Memorandum

To	Michael Czarnecki		
Copy to	[REDACTED]		
From	[REDACTED]	Tel	(07) 3316 3000
Subject	Webber Esplanade revetment wall	Job no.	[REDACTED]

COOK SHIRE COUNCIL
WEBBER ESPLANADE
REVTMENT WALL AS-BUILT
DESIGN CHECK - SHEET 1 OF 2

COOK SHIRE COUNCIL
WEBBER ESPLANADE
REVTMENT WALL AS-BUILT
SECTION REVIEW - SHEET 5 OF 6

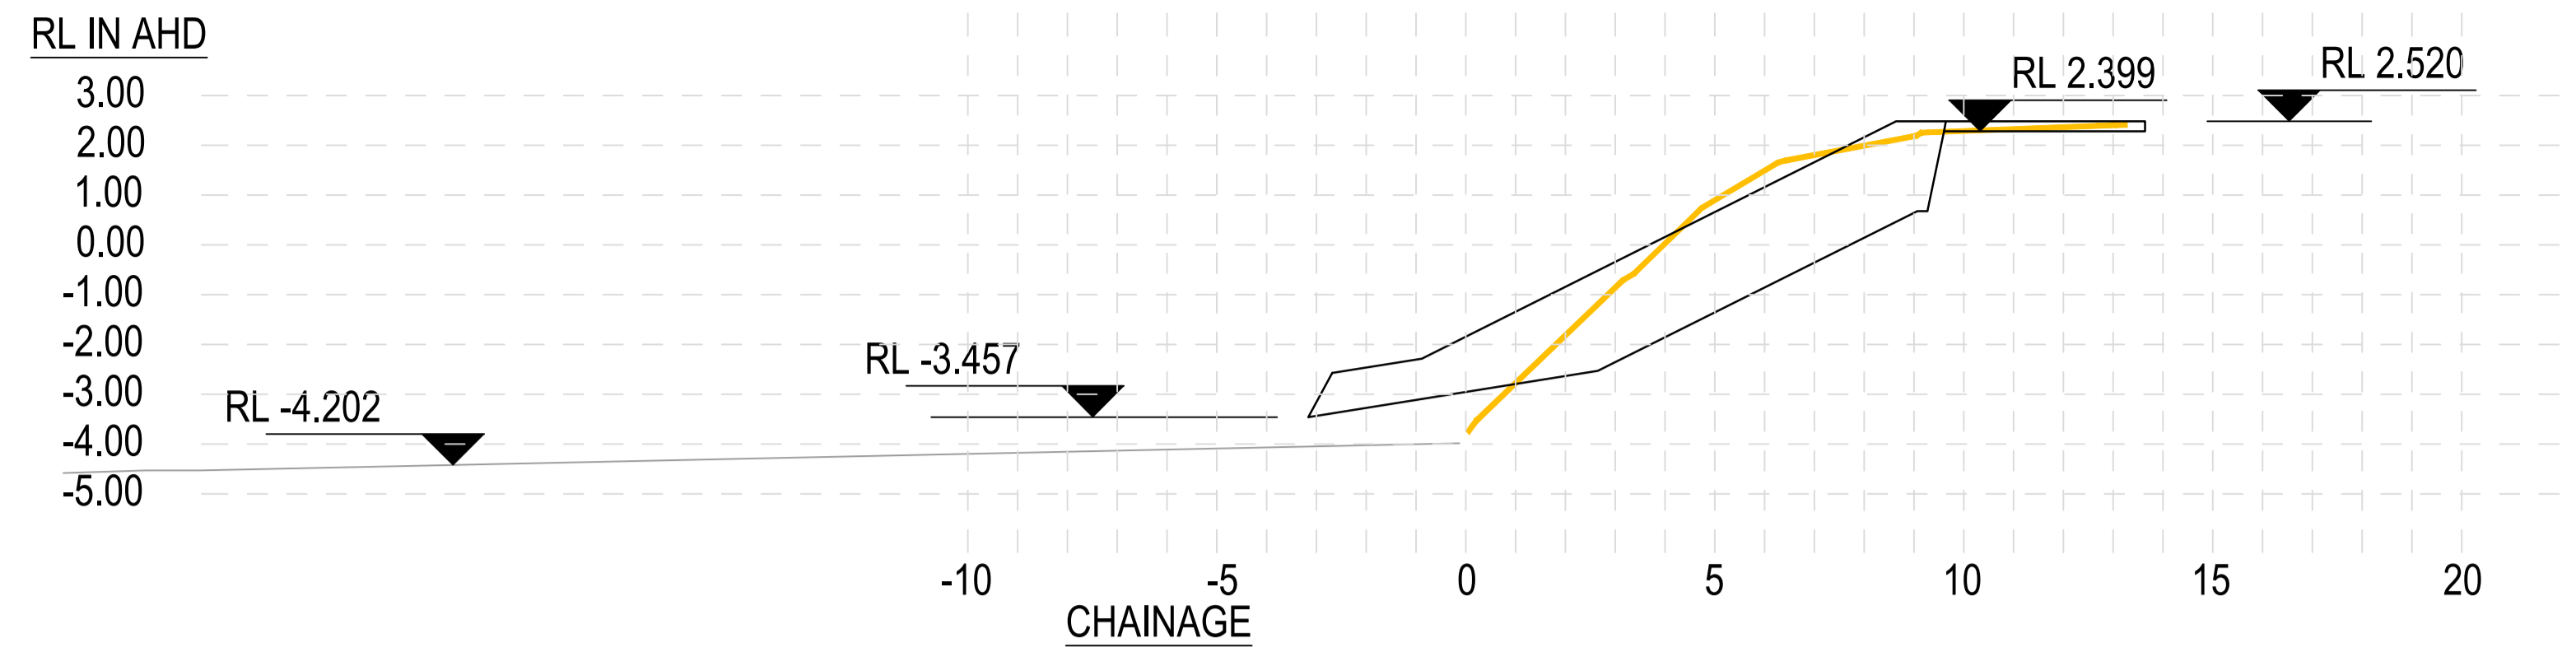
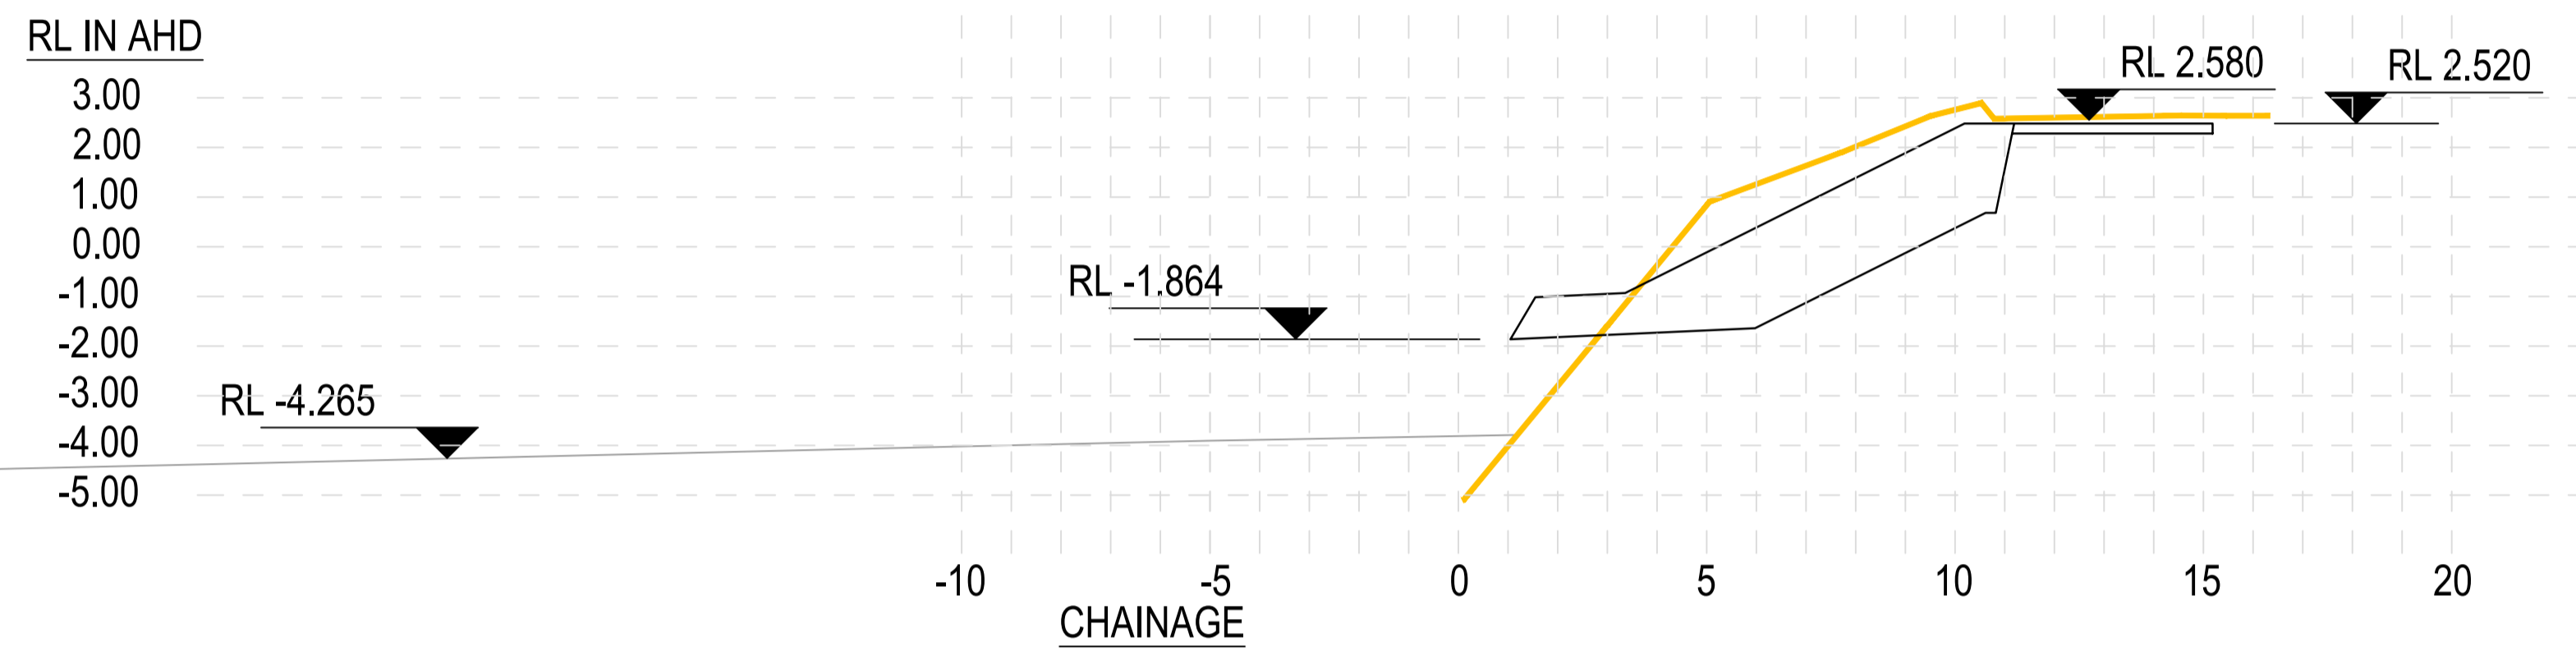
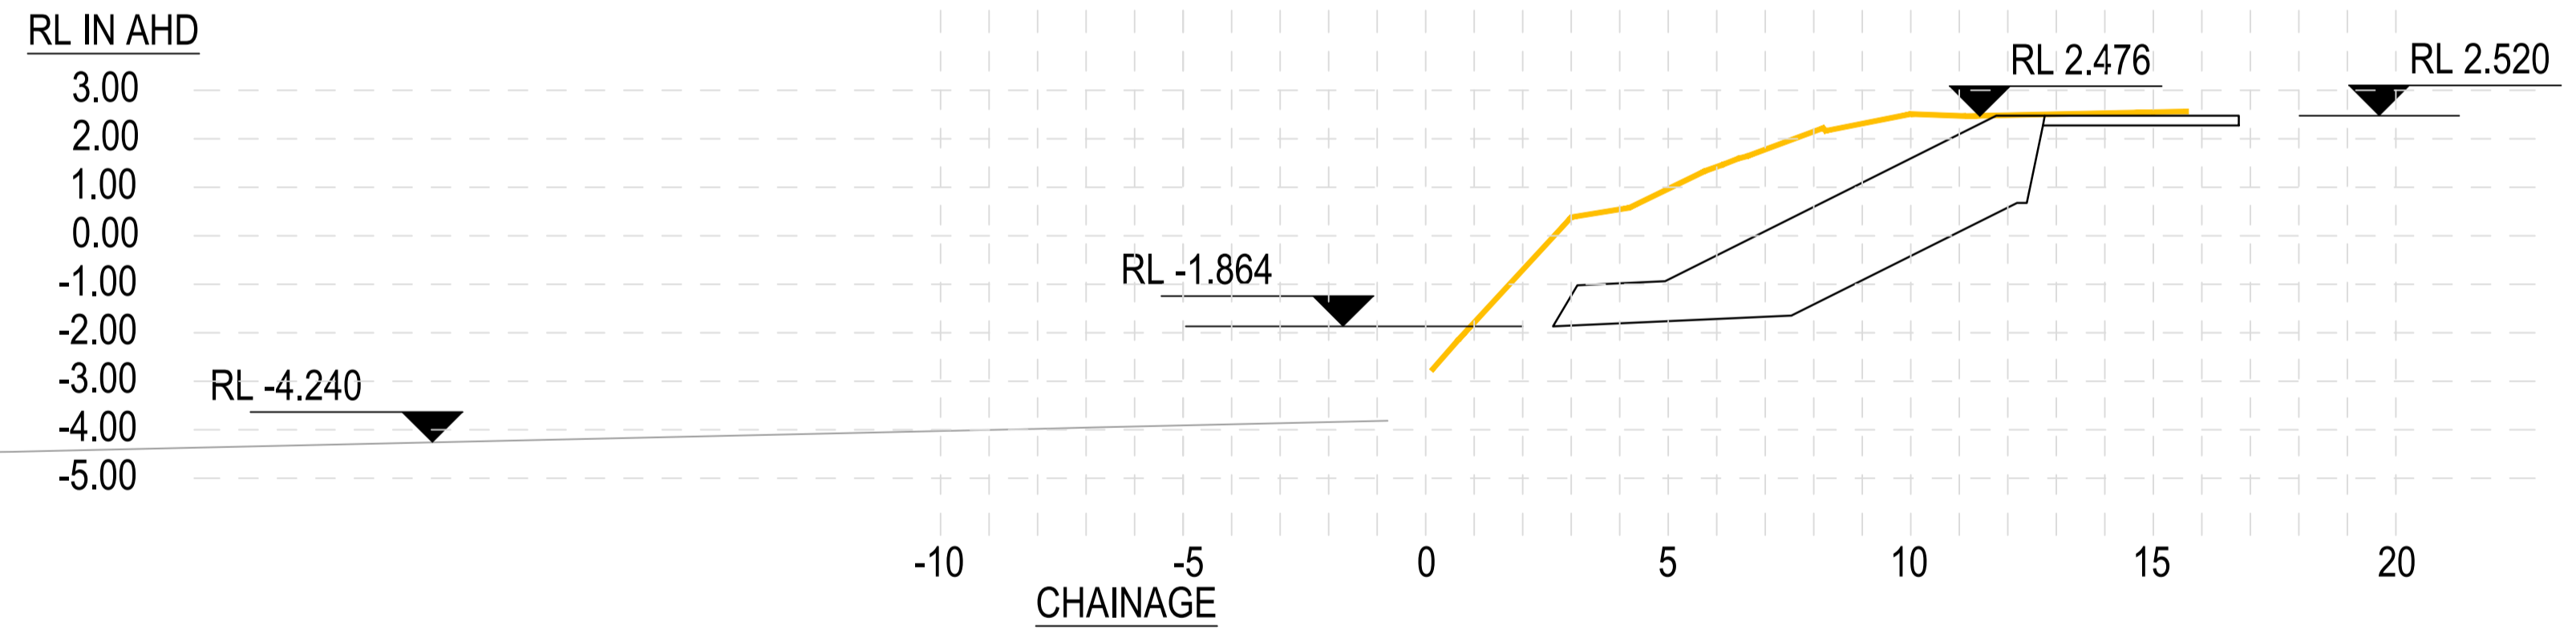
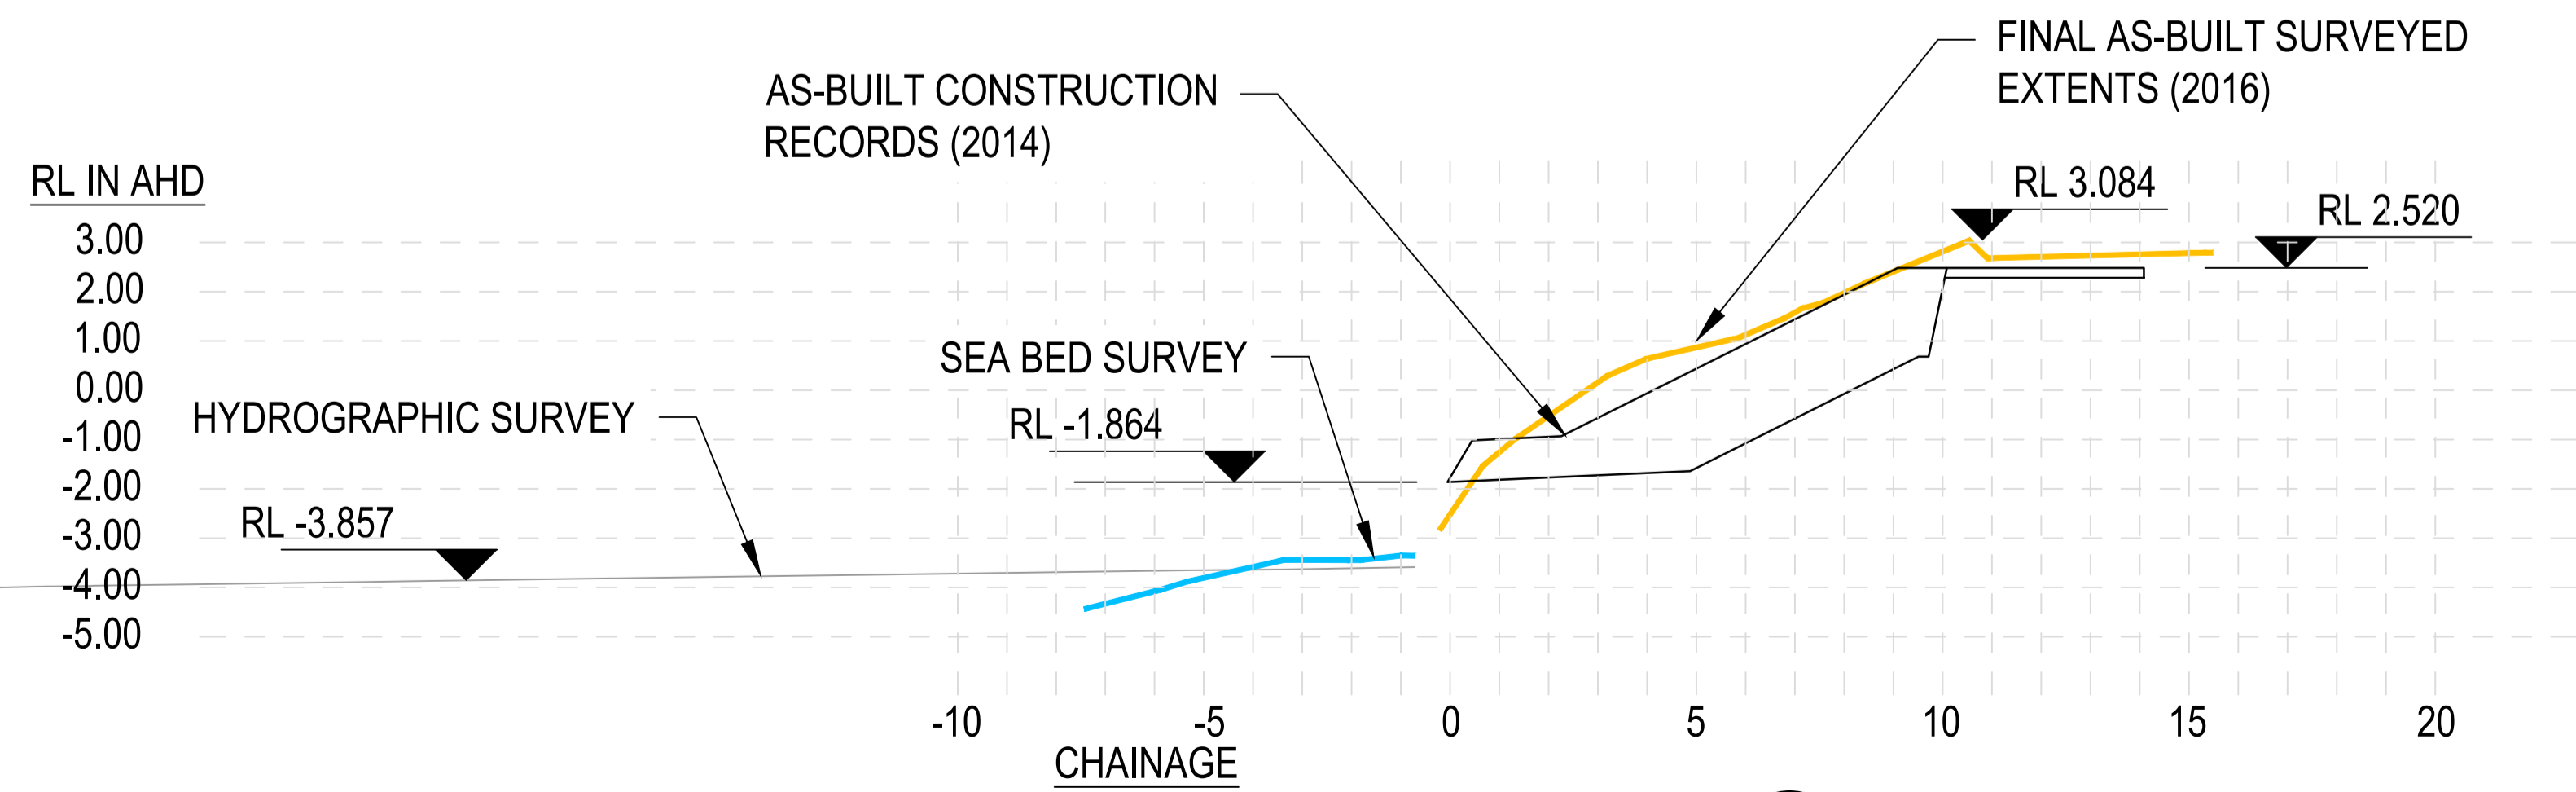
- The constructed slope is somewhat variable, with sections slopes 1, 2, 3, 4, 5, 6, 7, 8, 9, 10, 11, 12, 13, 14, 15, 17, 18, 19, 21 and 24 generally flatter than the design slope of 1 vertical to 2 horizontal.
- Section 20, 22, 23 have a steeper slope than the design slope of 1 vertical to 2 horizontal.
- For the majority of sections, the rock toe is not clearly distinguishable compared to the design profile.
- It is noted that complete survey coverage over the complete design profile, has not been provided in sections 22, 23 and 24.
- Survey of the seabed has not been provided. To aid further investigation, survey of the seabed is recommended.

The 'as-constructed' survey shows that the crest level, for most sections in attached 41-29566 SK-001 to SK-008, has generally been constructed above the design level of +2.52 m AHD. Sections 21 through to 23 show a finish level slightly below the design level of +2.52 m AHD.
